North Stonington School Modernization
 297/298/311 Norwich-Westerly Road
 North Stonington, CT 06359

Switchboards

Product Data, Shop Drawings & Manufacturer's Instructions

SUBMITTAL/DRAWING REVIEW COMMENT RESPONSES

PREPARED BY KENNY BRYSON	DATE 6/21/2018	Eaton		SumterSC	
APPROVED BY	DATE	JOB NAME North Stonington Schools-V0880221X8K1	DESIGNATION SWBD		
VERSION 9.0.8.0	TYPE Switchboards	DRAWING TYPE CustAppr			
NEG-ALT Number V0880221X8K1-R001	REVISION 0	DWG SIZE DwgA	G.O. LBS0019150	ITEM 002	SHEET 2 of 4

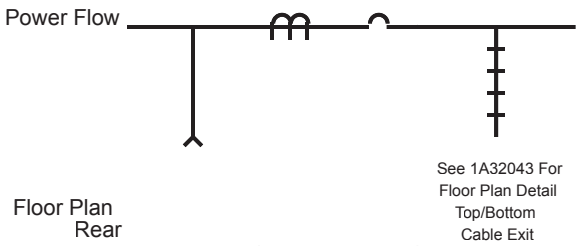
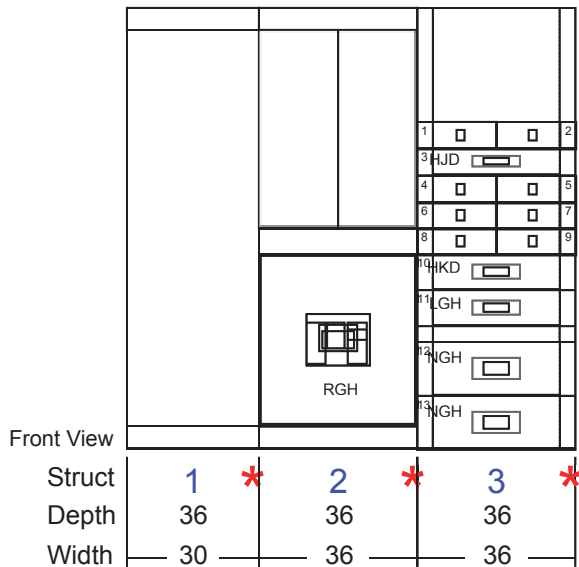
1. PROVIDE 80" TALL SWITCHBOARD
2. PROVIDE INCOMING AND BRANCH PULL SECTIONS AS REQUIRED.
3. PROVIDE ELECTRONIC TRIP UNITS FOR ALL BREAKERS CALLED OUT IN THE SCHEDULES.
4. COORDINATE AIC RATING OF SWITCHBOARD WITH OVERCURRENT & ARCH FLASH ANALYSIS.
5. COORDINATE SWITCHBOARD CONFIGURATION WITH THE LOCAL UTILITY COMPANY.
6. ADJUST BREAKERS PER THE OVERCURRENT & ARCH FLASH ANALYSIS.

1. SWBD Provided 90" tall per discussions with Banton Construction
2. Pull Sections Provided
3. Electronic trip units provided on all breakers call out for in the schedule per the Addendum
4. AIC Rating Coordinated with the SCC & Arc Flash Studies
5. Contractors responsibility
6. Breakers settings to be Field Adjusted.
